ATTENTION	Expert Consenting Panel - Ashbourne
SUBJECT	Response to Minute 16
AUTHOR	Clare Houlbrooke

This memorandum provides a response to Minute 16, the Ashbourne Development.

The panel have requested a response to concerns on the mounding assessment for proposed Stormwater Basin A raised by Mr Williamson.

Figure 1: Dry Conditions Monitored in Two Piezometers at the Proposed Basin A

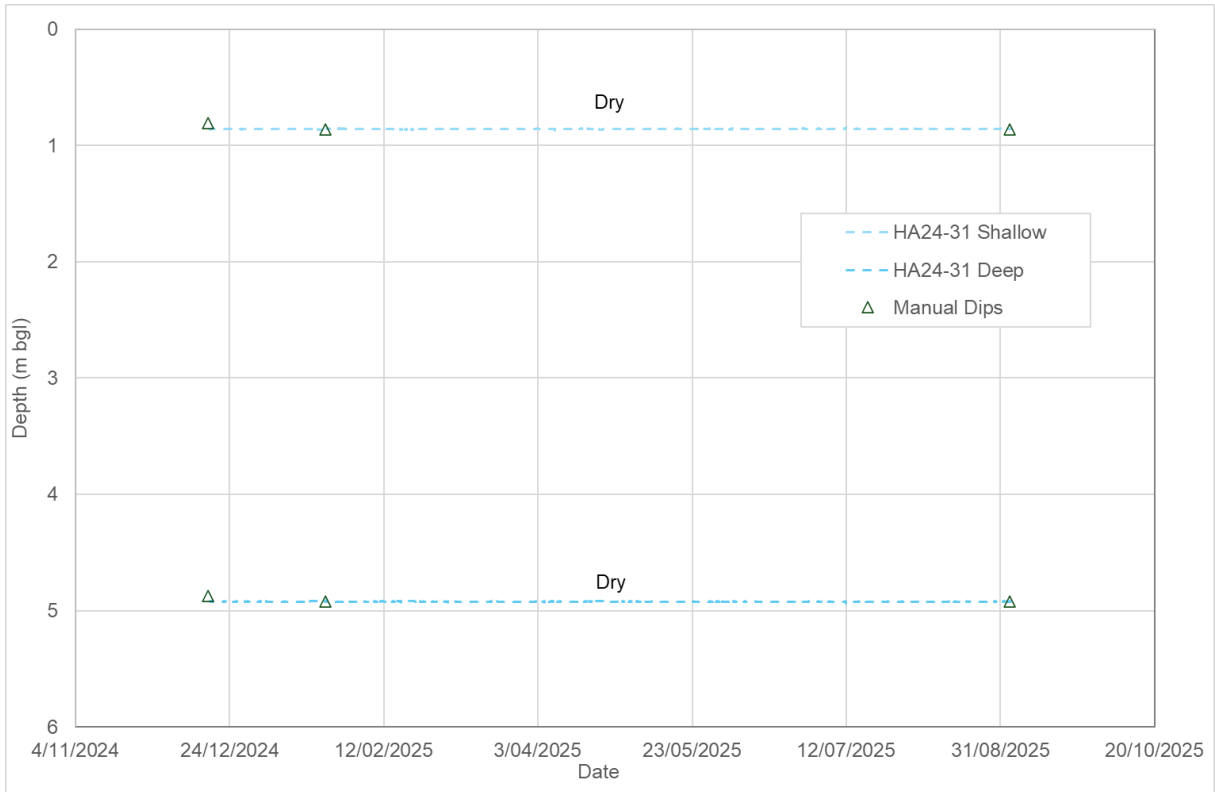
Mr Williamson has raised a concern that the starting groundwater levels prior to a major storm event may not be conservatively high. He is aware and acknowledged that various iterations of the mounding simulation started with initial groundwater levels at 3.5 m below the top of the basin (btob; 66.5 m RL), 5.2 m btob and 6.0 m btob. WGA considers that these simulations are reasonable, especially given that the model with a starting groundwater level of 3.5 m btob is conservative with respect to the starting level. This conservatism has been shown by observed groundwater levels being much lower than the maximum starting level modelled, even during higher rainfall periods, as detailed below.

Manual measurements and continuous automated monitoring using pressure transducers were in place in two piezometers in the location of Basin A from December 2024 until August 2025. During this time no groundwater was detected in these piezometers, i.e. they were dry for the full monitoring period (Figure 1). The rainfall during February and March 2025 was below average (Figure 2 and Figure 3). However, since that time, monthly rainfall has been predominantly at or above average, with the exception of August 2025. The two piezometers were replaced with 25-P3, which subsequently recorded a maximum level of 5.3 m below ground level in a record extending into December 2025 (Figure 4). Therefore, modelling a groundwater level at 1.7 m above observed levels during a relatively high rainfall recharge year is considered sufficiently conservative (initial model at 3.5 m btob).
